SEP Operation
7 Engineering
Maintenance
Buildings

CDR Phase 2

December 2024

CDR Phase 1 Comments

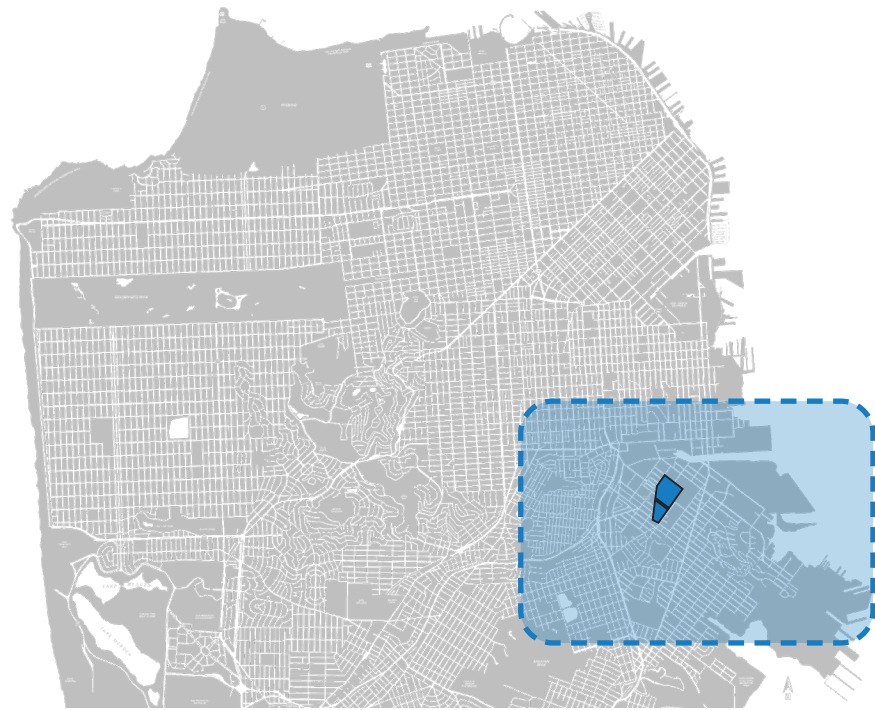
Comments:

Study balance of security and human scale at street level

Design Responses:

- Added more windows at street level
- Added a gradient to translucent glass for variation
- Provided precast panels of varying widths
- Added facade lighting
- Added street trees
